Plan Commission

Monday, August 22, 2022

SUBJECT: Consideration and possible action on an amended Precise Implementation Plan for a proposed drive-in or convenience food establishment at 1610 Lawrence DR (Parcel WD-D0015-2-1). *

- ITEM 5:** Consideration and possible action on an amended Precise Implementation Plan for a proposed drive-in or convenience food establishment at 1610 Lawrence DR (Parcel WD-D0015-2-1). *

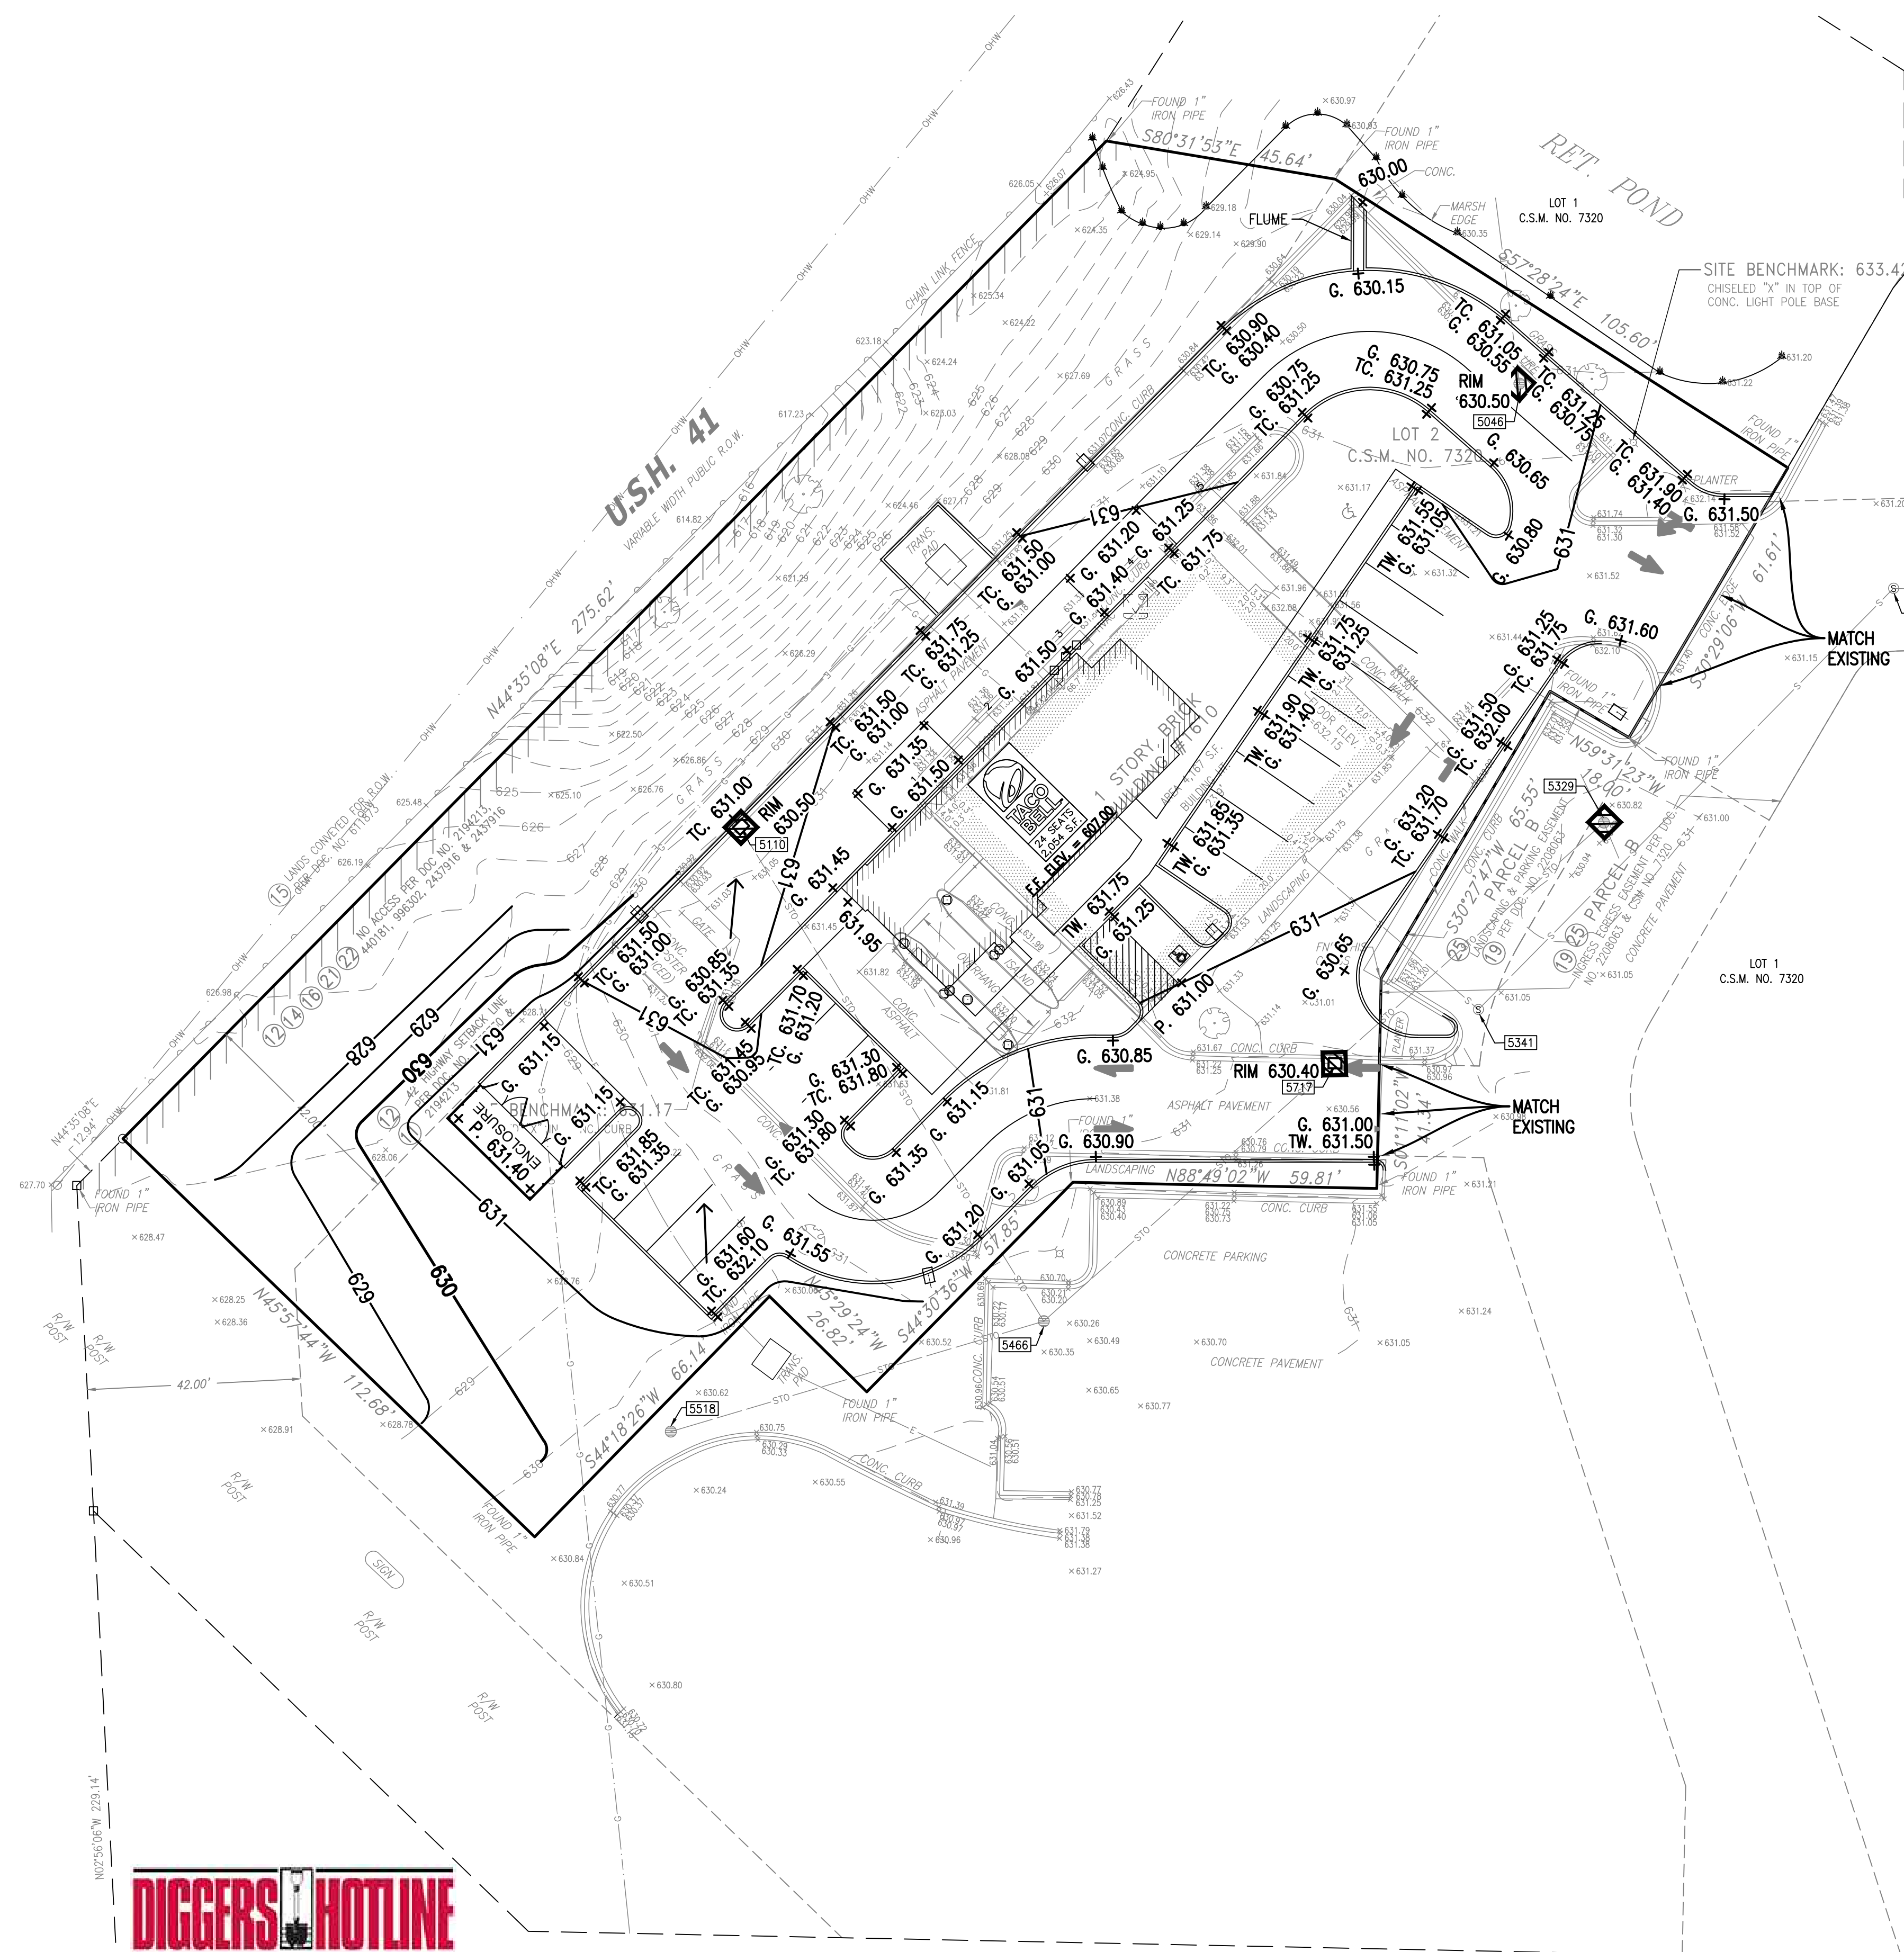
2. Sheet CE-3 Comments.
 - a. Sheet is incorrectly numbered as CE-2 on bottom right.
 - b. Drive through aisle and driving lane around the north and west side of the building need to be 24-feet wide total. Currently is laid out as 23-feet wide.

SCALE: 1"=20'
PROJECT NO. 22027
DATE: 7/29/2022
SHEET NUMBER
CE-3

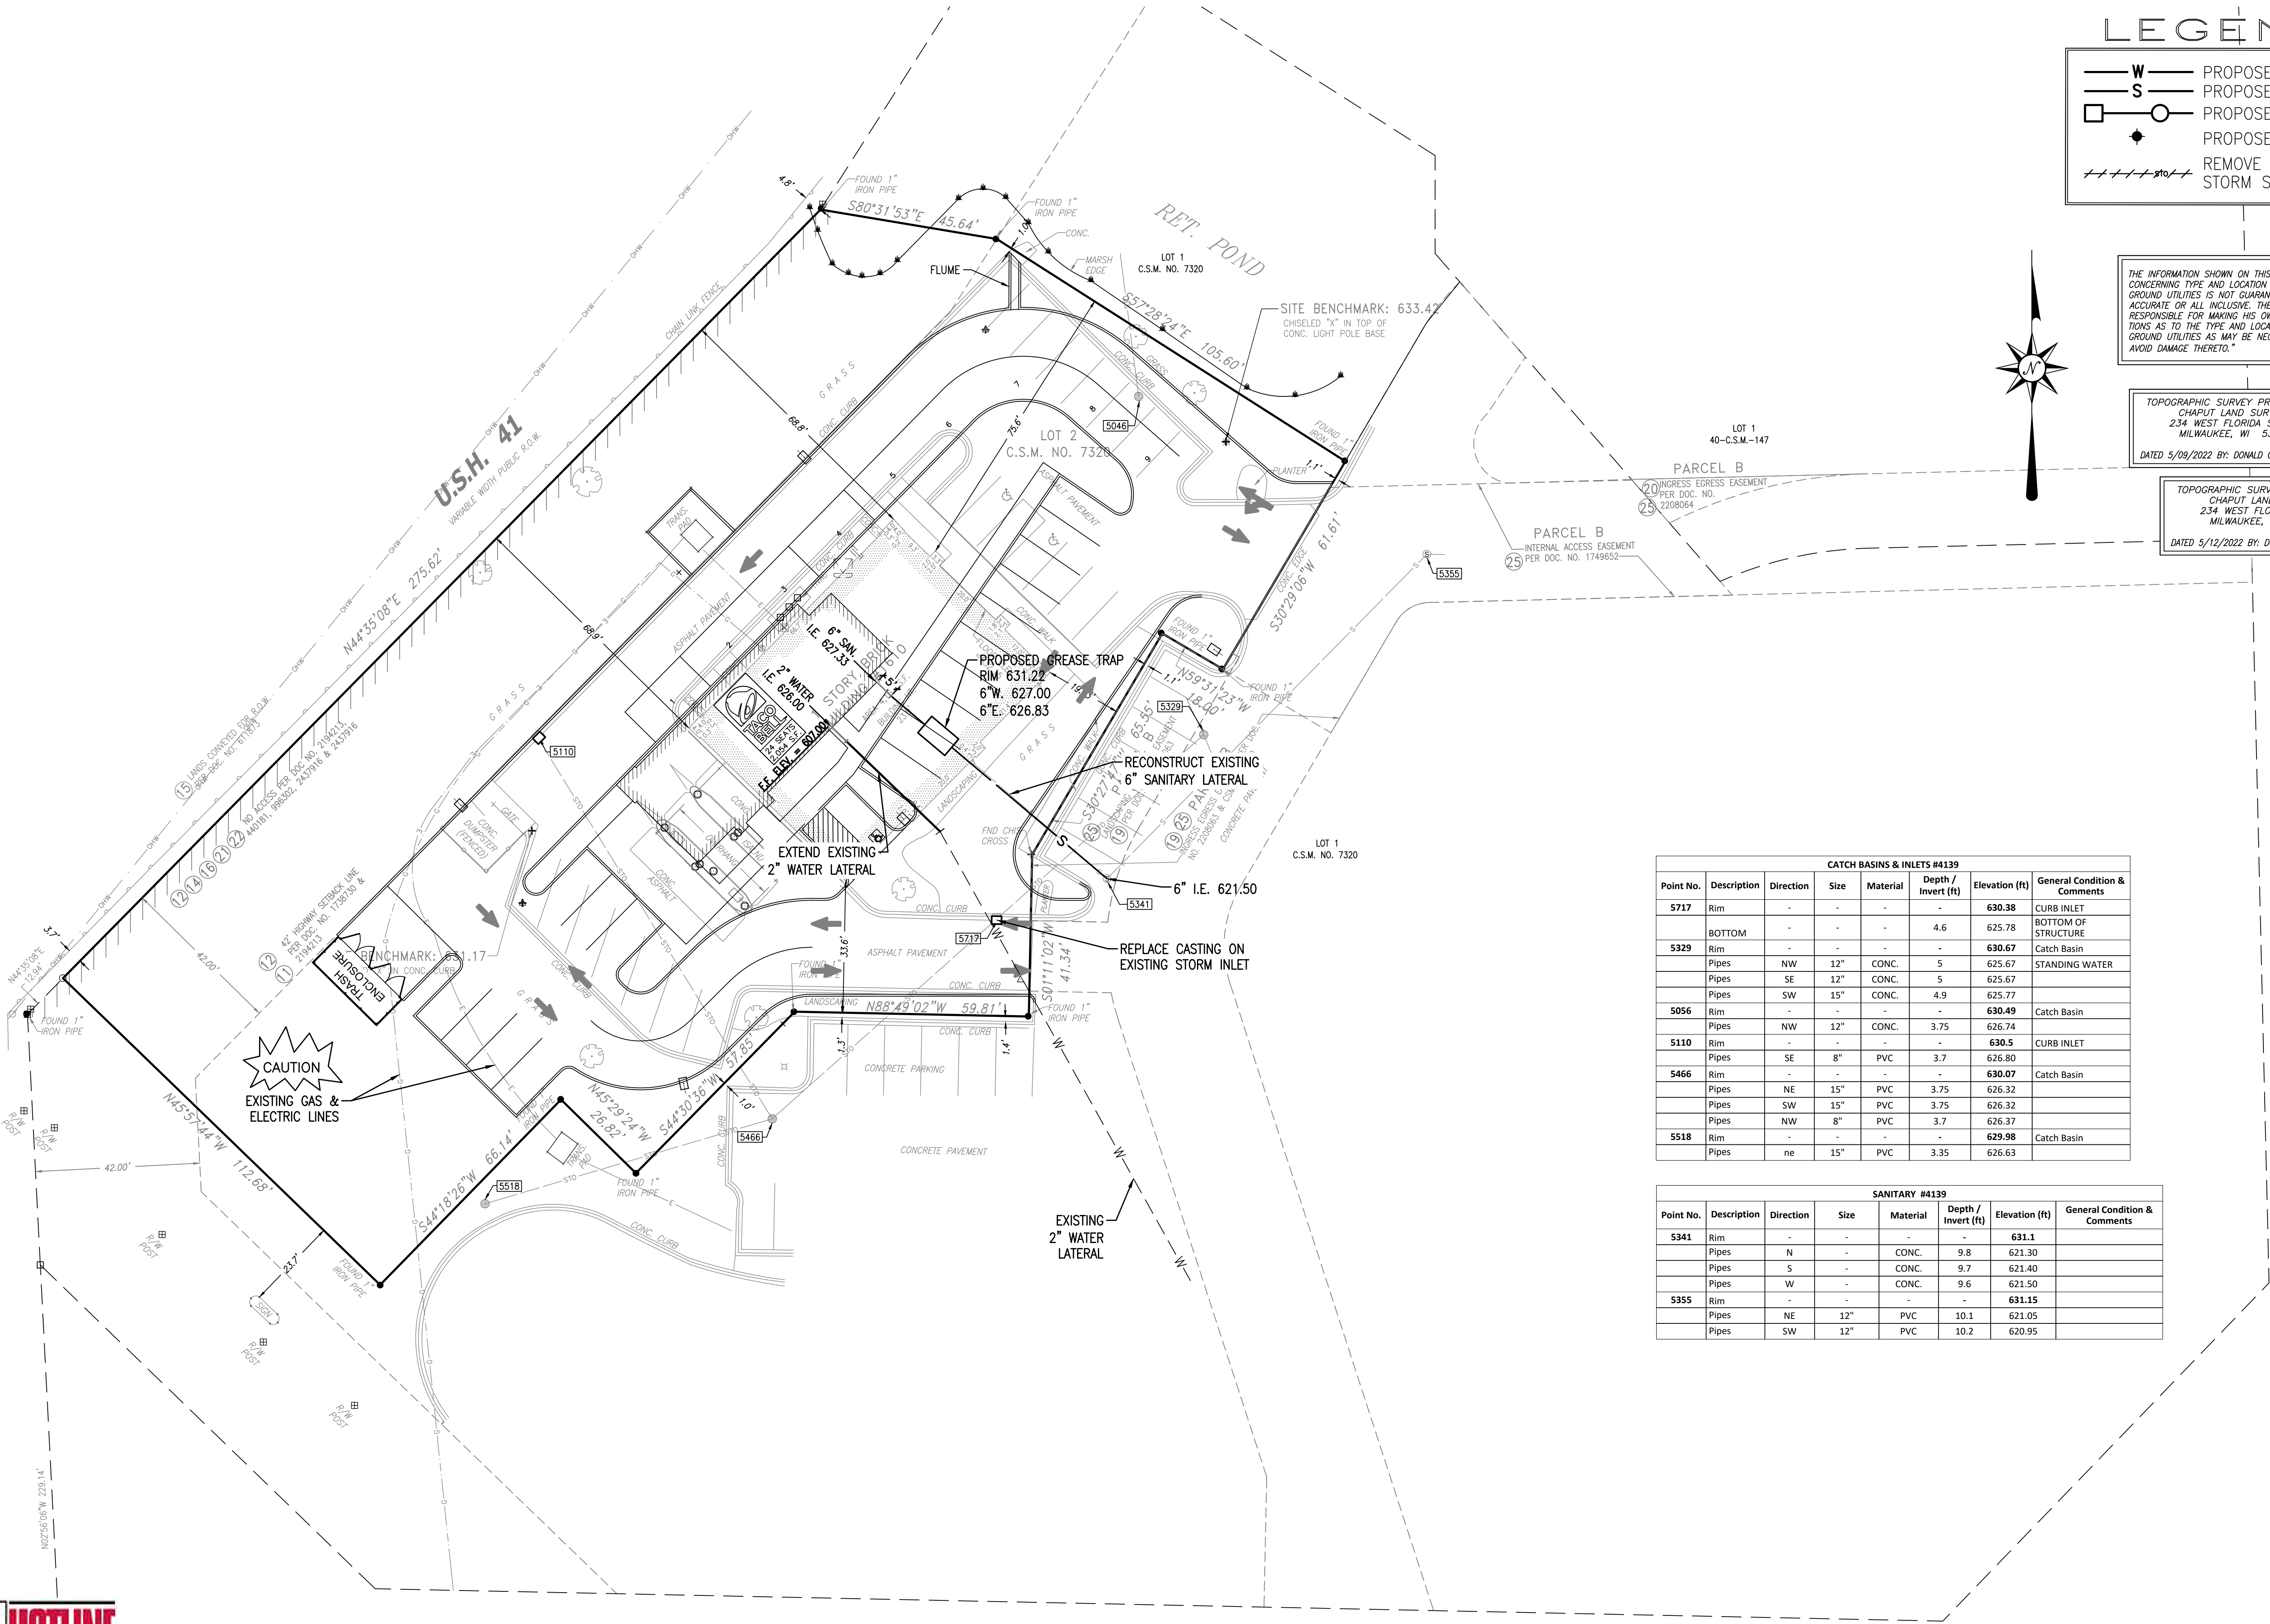
- f. Specify the water meter size. Larger meters may have a multi-month procurement period.
3. Sheet CE-4 Comments.
 - a. Sheet is incorrectly numbered as CE-3 on bottom right.

- b. On the catch basins and inlets table, clarify if structure 5056 is supposed to be 5046 or something else.
 - c. Provide WisDNR Soil Loss Sediment Discharge calculations and corresponding map.

- d. Identify where the tracking pad is specified for this site. If there is none or an alternative, identify so for approval.
4. Sheet CE-5 Comments
 - a. Sheet is incorrectly numbered as CE-4 on bottom right.
